SCH3227/SCH3226/SCH3224/SCH3222 Silicon Errata and Data Sheet Clarification

Data Sheet Clarifications

Note: The following typographic corrections and clarifications apply to Data Sheet Document #00002121A, which is at Revision A, and specifies only the family members SCH3222, SCH3224, SCH3226 and SCH3227. Other members of the SCH322x family have separate data sheets, and separate errata sheets.

1. Module: Serial Port

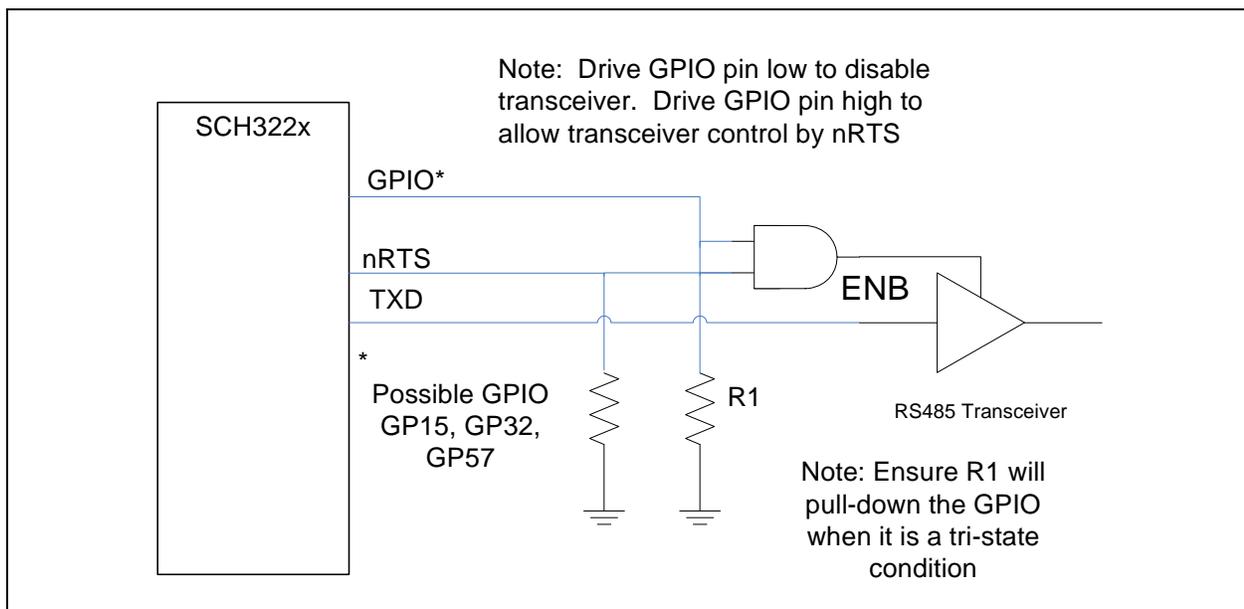
UART 3 and UART 4 do not tri-state their outputs on a PCI_RESET as do UART 1 and UART 2.

UART 3 and UART 4 outputs are not controlled by the Configuration Register 0x30 ACTIVATE bit.

UART 3 and UART 4 outputs will drive High when PCI_RESET goes active or when the ACTIVATE bit is cleared, and if the platform uses RTS to control an RS485 transceiver this may interrupt communication.

Use GPIO pin to disable RS485 transceiver when ACTIVATE bit is cleared.
